Drawing Title			
Proposed Elevations Unit 3			
Scale:	Date:	Drawn:	Checked:
1:50 @ A1	Dec 2019	Craig Harrison

5766 - T06G

Proposed Dwellings
Land at Victoria Terrace
Mellor Brook

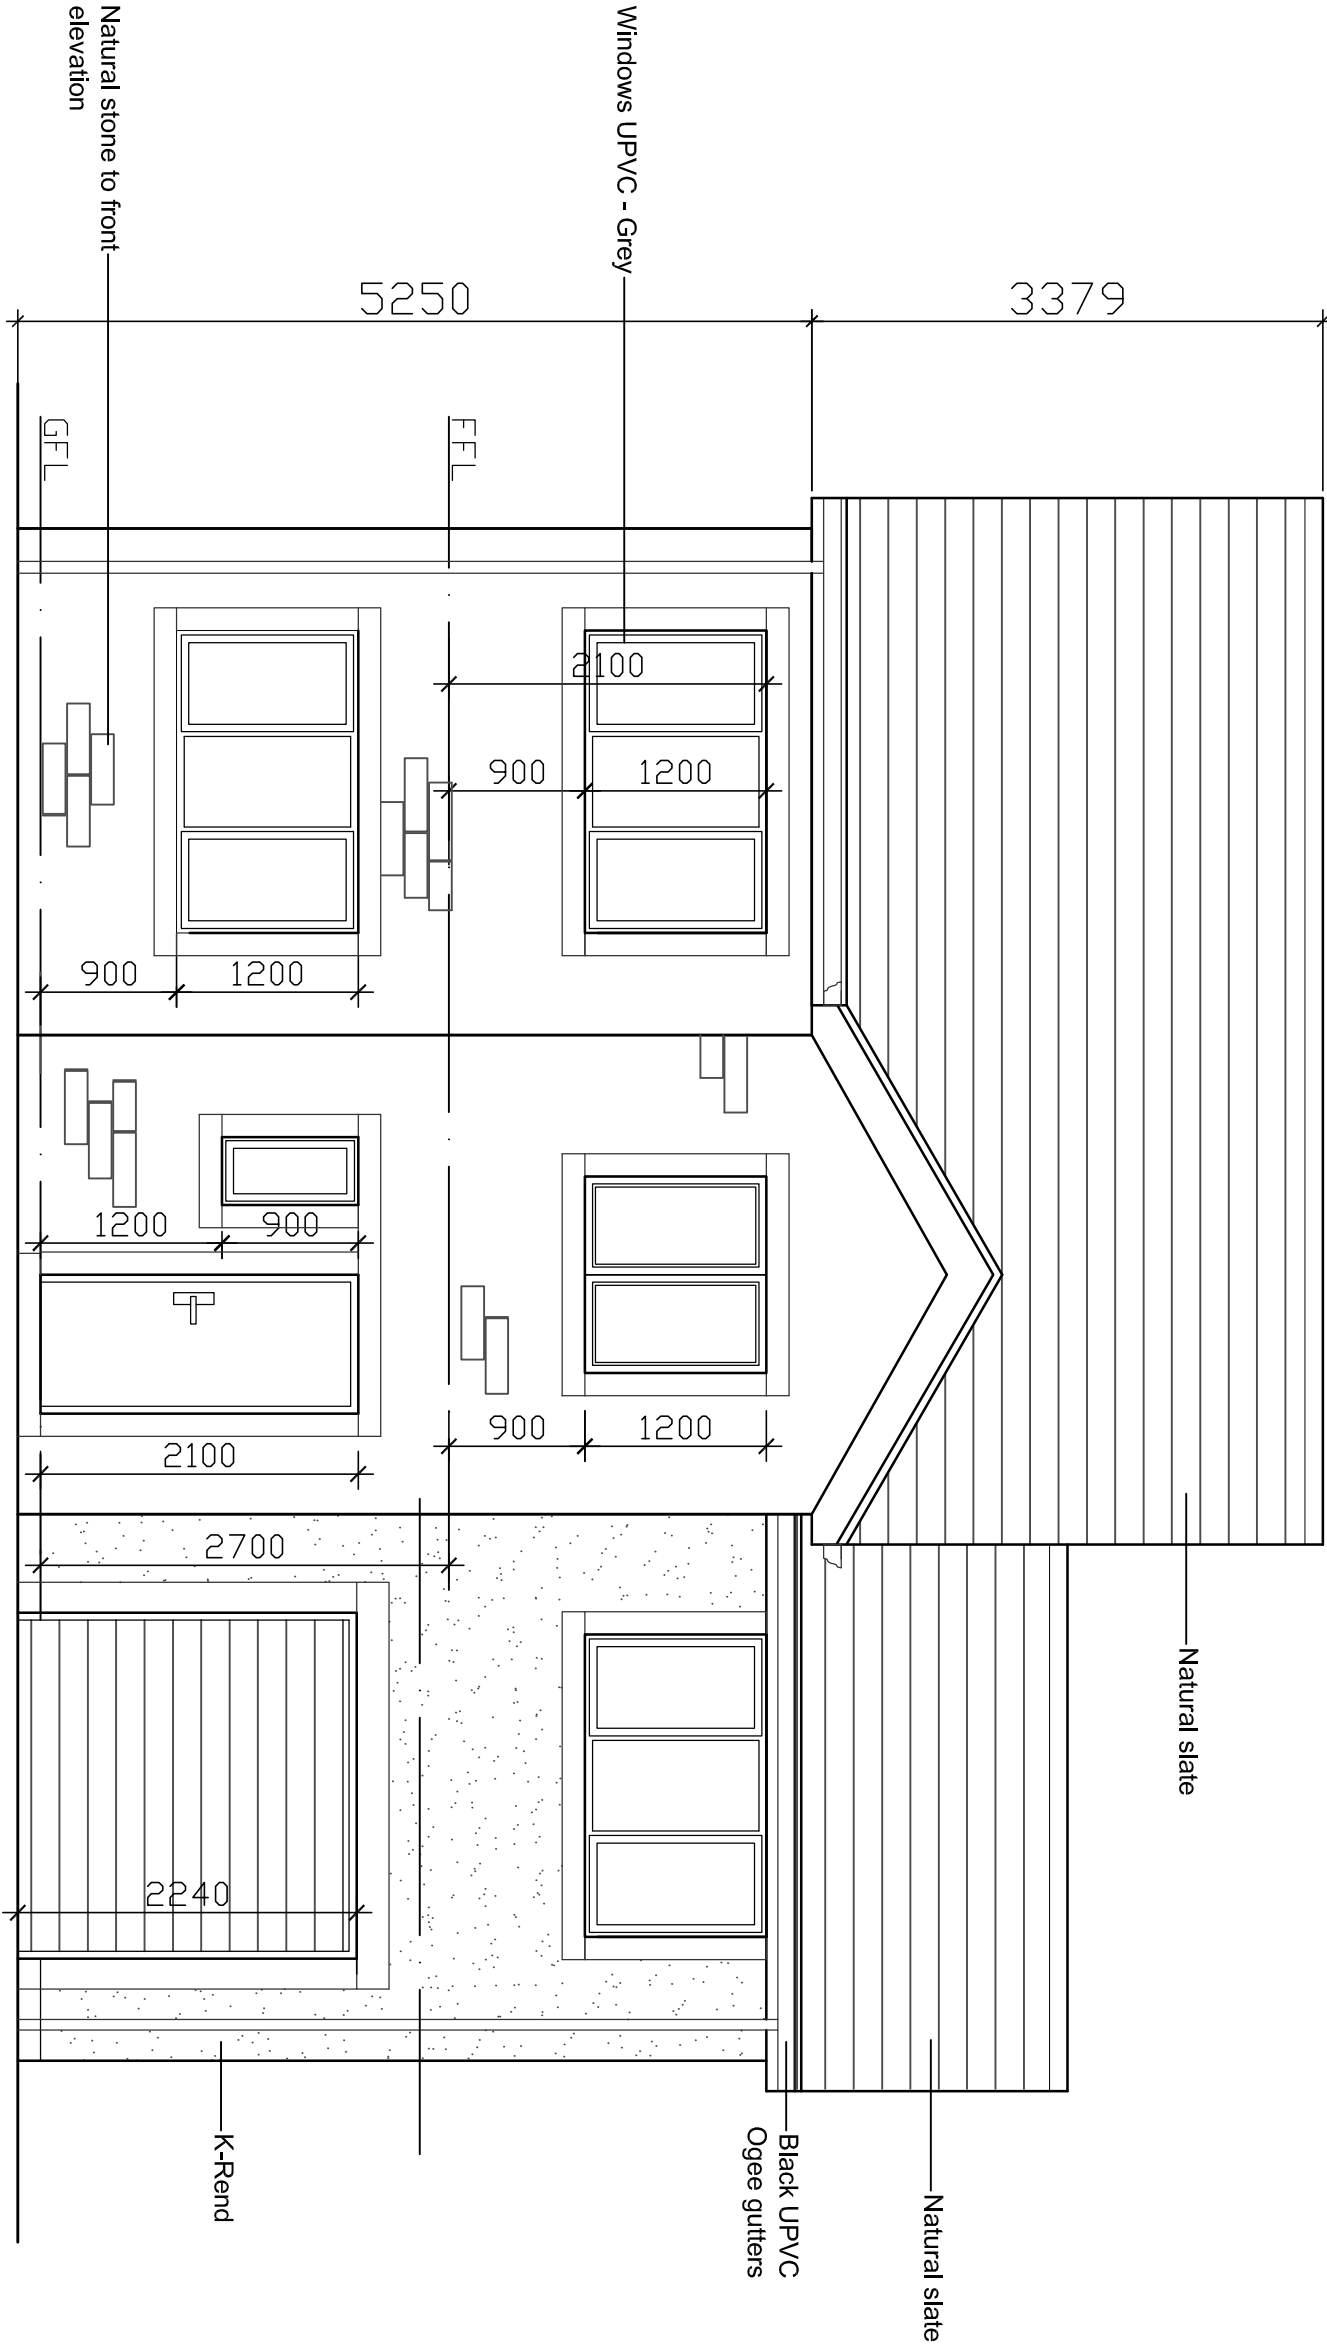
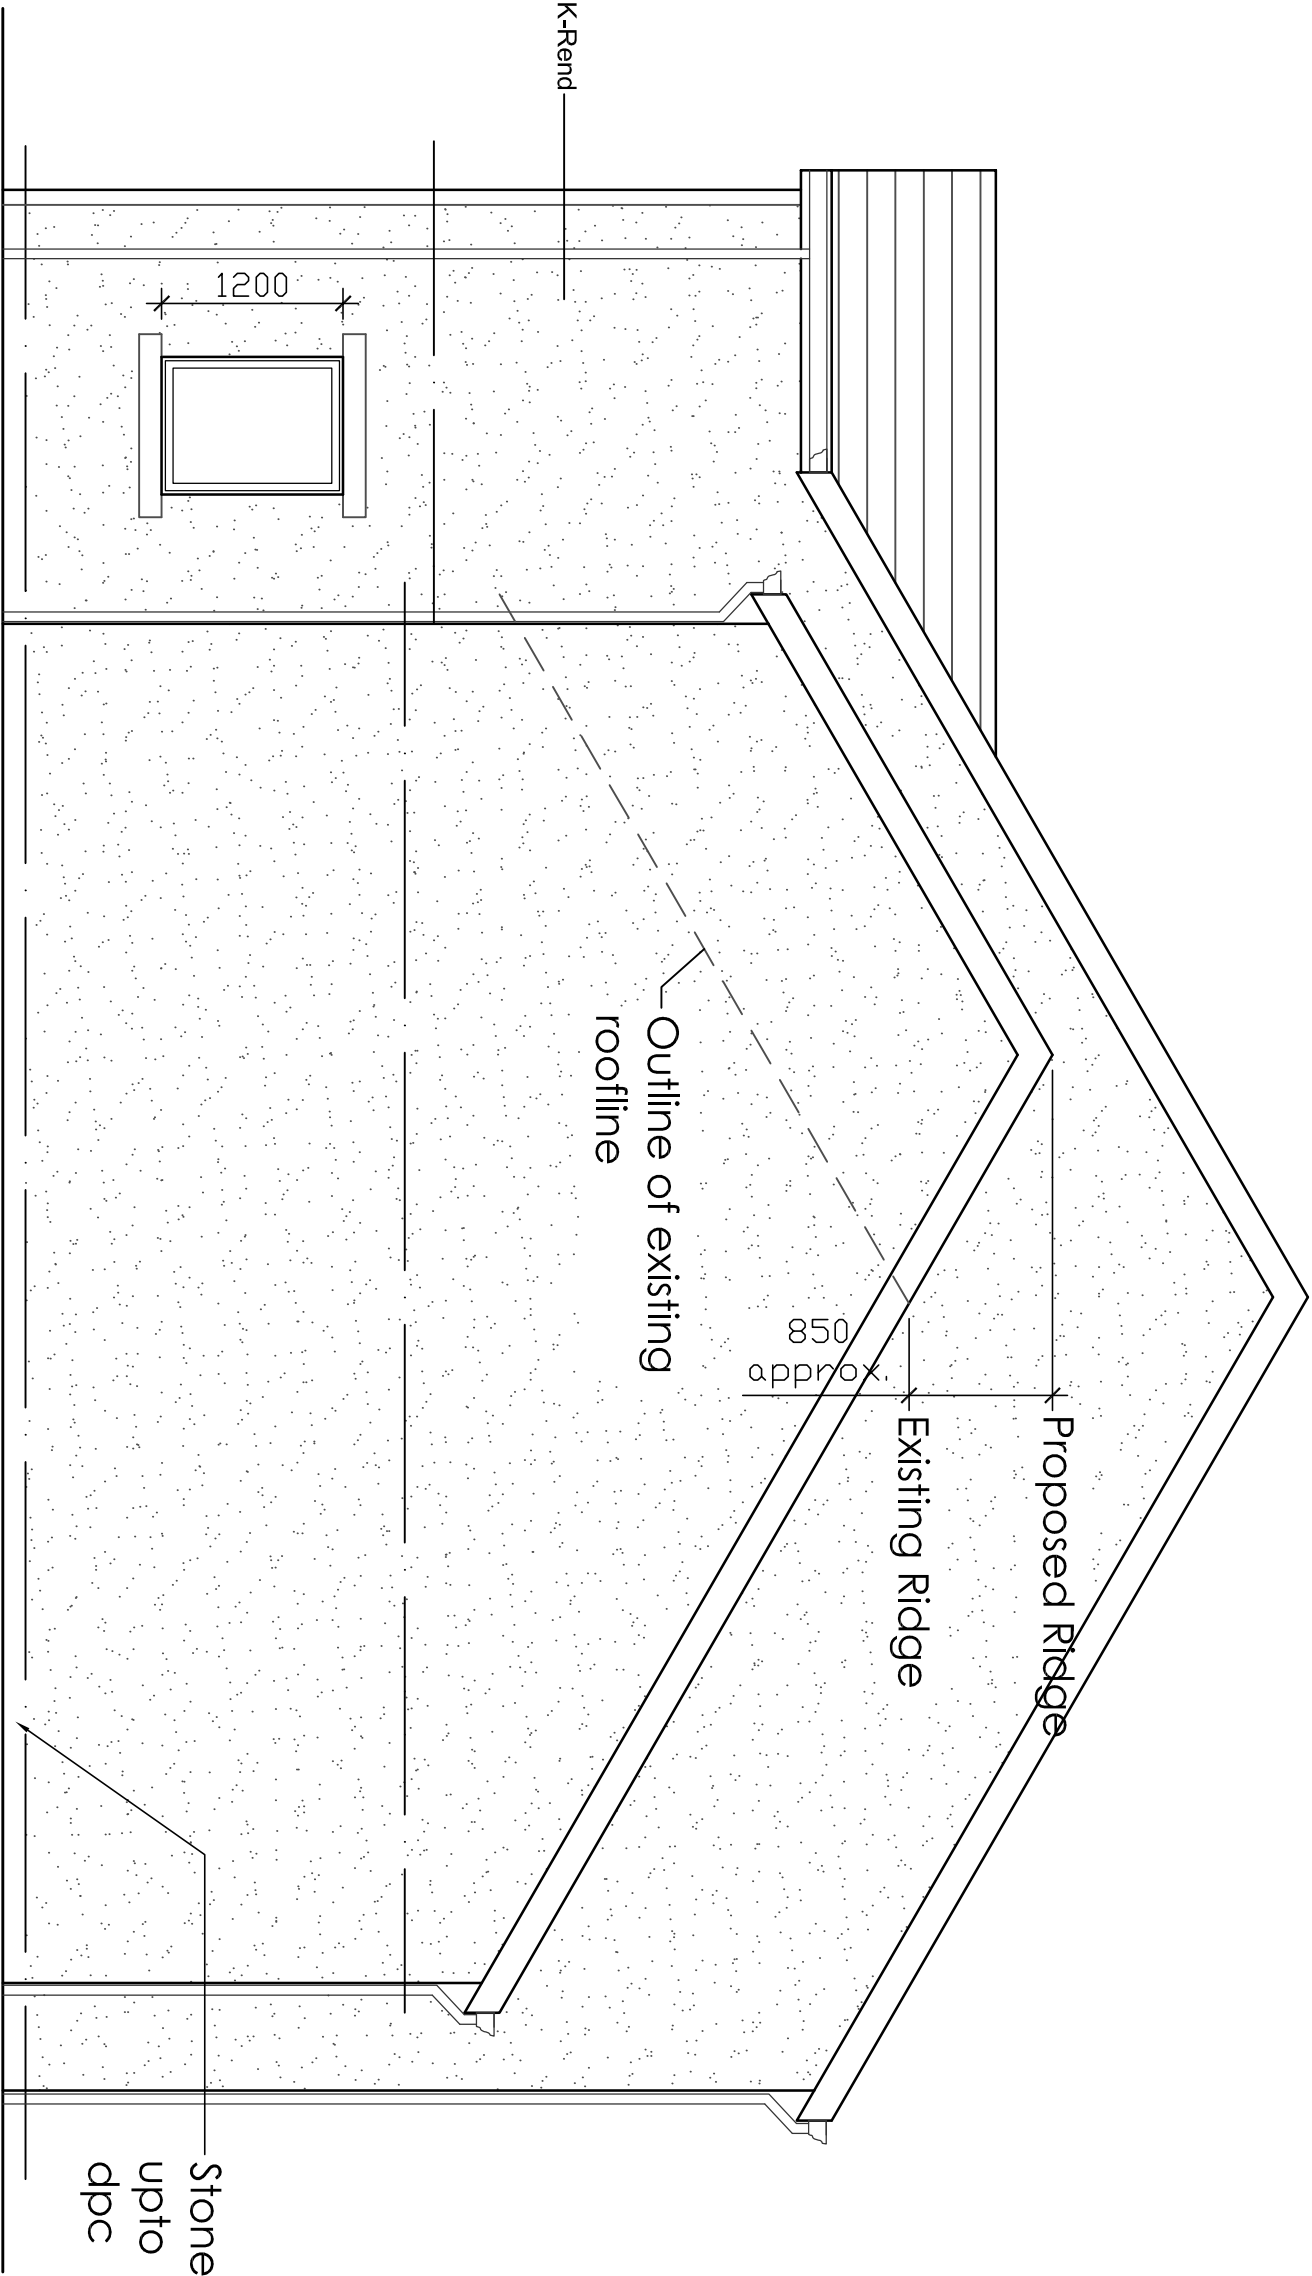
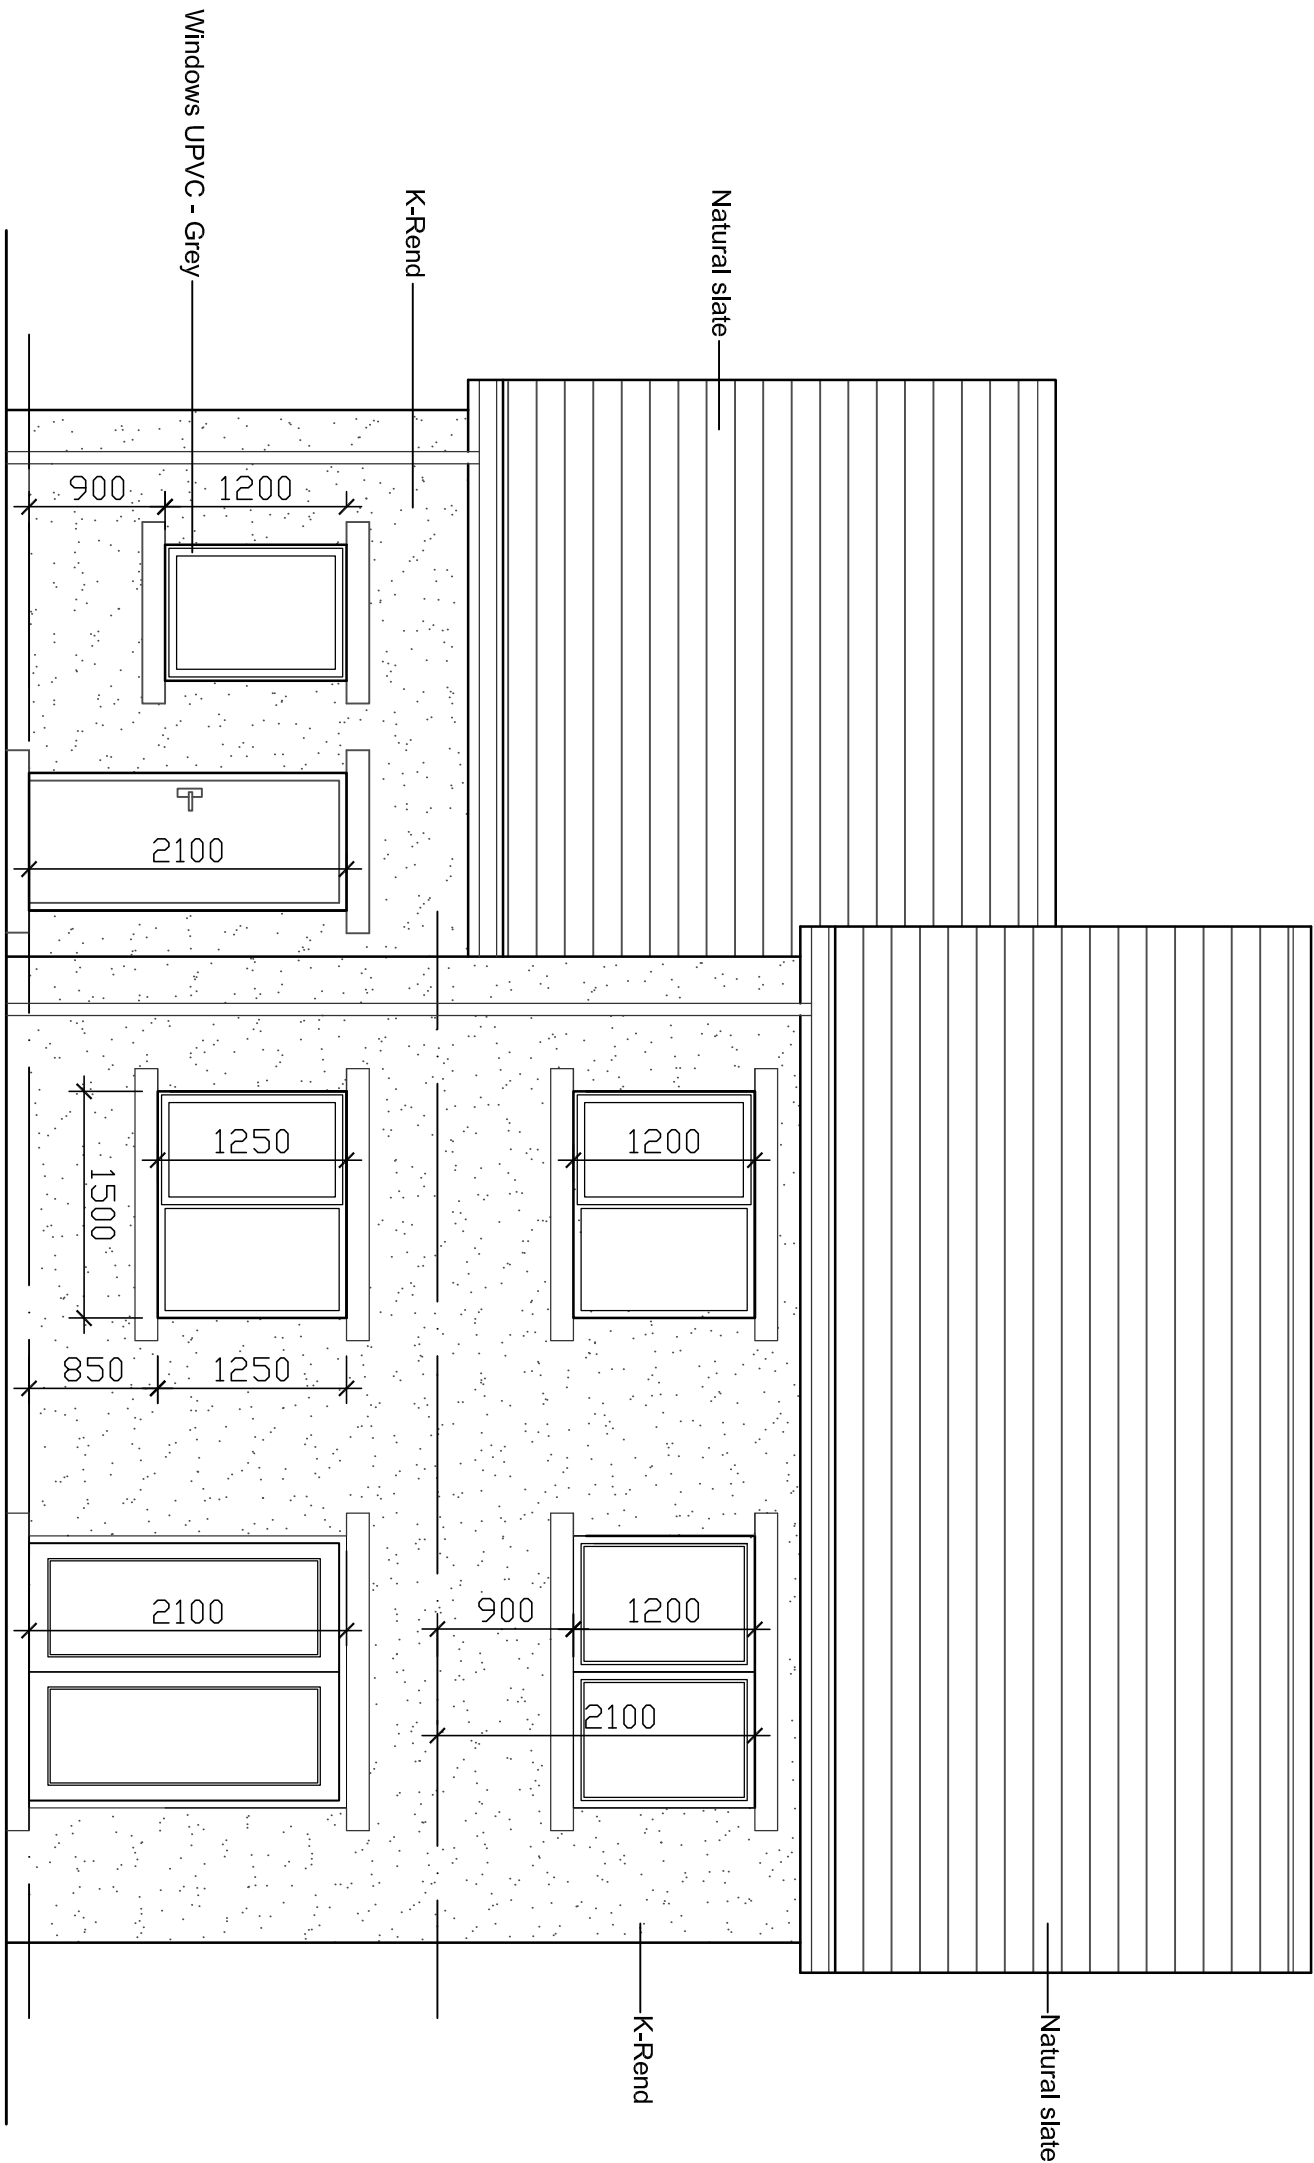
Rev G: Change window over Garage to 3 pane, as requested by RVBC, 29.07.2021
Rev F: First Floor extension proposed over garage - Variation of condition application, 14.05.2021
Rev E: First floor extension omit from over garage, materials changed to stone to front elevation with K-Rend to sides and rear, 13.05.2021
Rev C: Client alterations as per marked up sketches, 18.05.2021
